# Rezoning Transportation Analysis

Petition Number: 2020-137

General Location Identifier: Tax ID 04922121

Date	Description
10-26-20	First Review
11-30-20	Second Review
12-28-20	Third Review

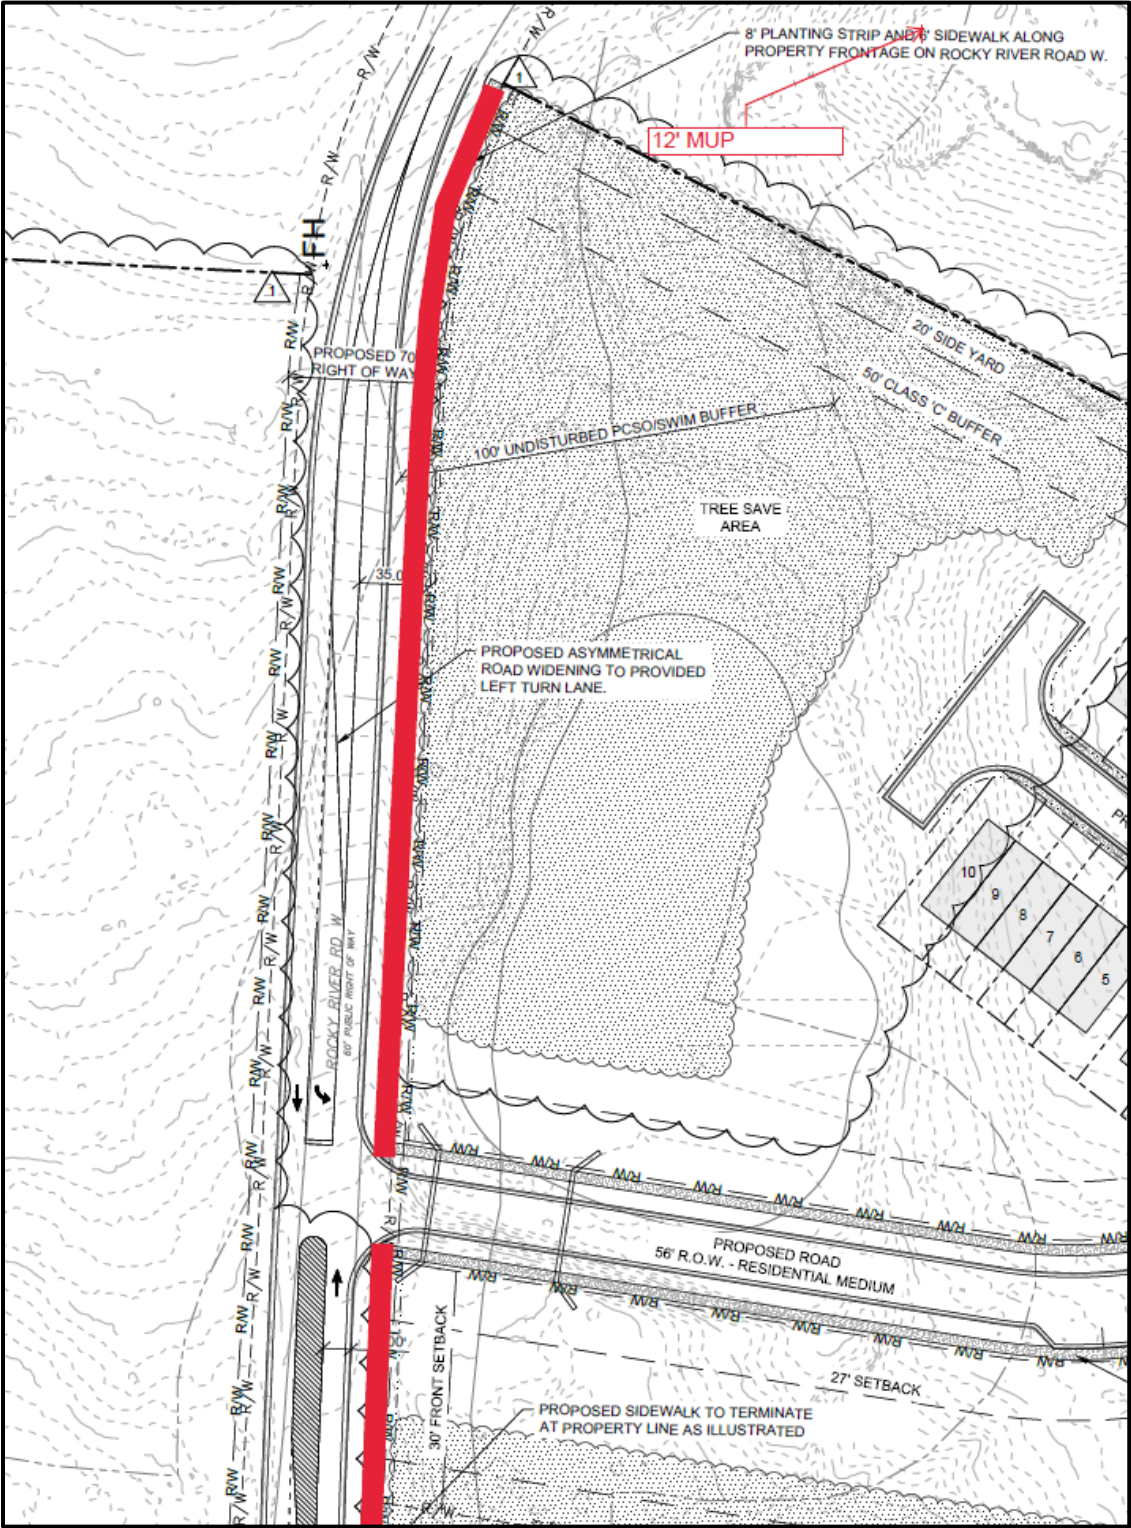
Revise the site plan and conditional note(s) to commit to dedicate connecting the northern development to Newell View Lane while providing a hammerhead at the western limits, reducing conflict points at the Rocky River Road West Intersection.
